**BOARD OF ZONING ADJUSTMENT  
STAFF REPORT****Date: April 1, 2013****CASE NUMBER**

5820

1916 Airport Boulevard  
(North side of Airport Boulevard, 405'± West of Myrtle Avenue)

## SITE PLAN

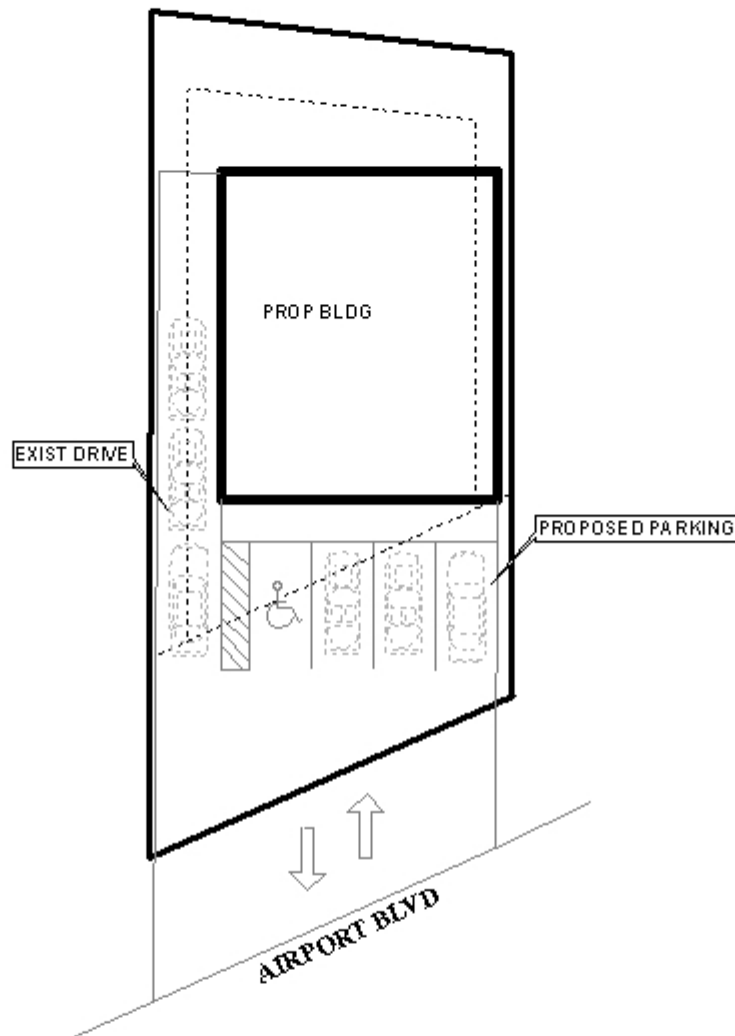
The proposed structure would now meet the 25' minimum front yard setback as opposed to the 18.7' setback of the previous structure which would at least allow vehicles to now be parked completely out of the right-of-way. However, only four compliant parking spaces are indicated, with other spaces stacked in the 9' wide driveway to the rear along the West side of the proposed structure. Aerial photographs indicate this to be the same parking ratio as the previous configuration. And all vehicles would still have to back into the right-of-way to maneuver.

Although not specified on the site plan submitted, the proposed side yard setbacks seem to be identical to those of the previous structure as shown on the 1994 survey of the site furnished. B-3 districts allow a zero or 5'+ side yard setback off adjacent commercial properties. As only about a 2' setback is proposed on the East side, this would not be compliant with the current requirements. A zero setback is allowed with the proper fire-rated wall, or a 5' minimum setback is required in order to allow Fire Department access in case of emergency. As the proposed structure would be placed further to the rear than the previous structure to within approximately 17' of the rear property line, and as a portion of the adjacent residential site to the East (behind the commercial site fronting Airport Boulevard) is within approximately 13' of the rear property line, this would place the Northeast corner of the proposed structure within approximately 4' of the residential property. The intent of the 10' minimum setback off adjacent residential properties is to provide a protection buffer and open space and to lessen visual encroachment. However, with a modification to the Northeast corner of the proposed building, the 10' setback off the adjacent residential site could be met.

With regard to the landscaping and tree planting requirements, the site could potentially provide adequate area to meet those requirements. However, as the rebuild is to be essentially the same size as the original structure, and as the site did not lend itself to satisfying many of those landscaping and tree planting requirements, the downsizing of the proposed building and the drastic reconfiguration of the site would seem harsh. There does appear to be some area in the rear yard to potentially provide a degree of compliance with the landscaping and tree planting requirements, though.

- 1) revision of the site plan to indicate the exact building setbacks off all adjacent properties;
- 2) revision of the Northeast corner of the proposed building to meet a 10' setback off all portions of the adjacent residential property to the East;
- 3) revision of the site plan to provide as much compliance with the landscaping and tree planting requirements within the rear yard as practicable; to be coordinated with Urban Forestry;
- 4) full compliance with all other municipal codes and ordinances, including any firewall ratings required; and
- 5) submission of two (2) copies of a revised site plan to Planning indicating the meeting of these conditions.
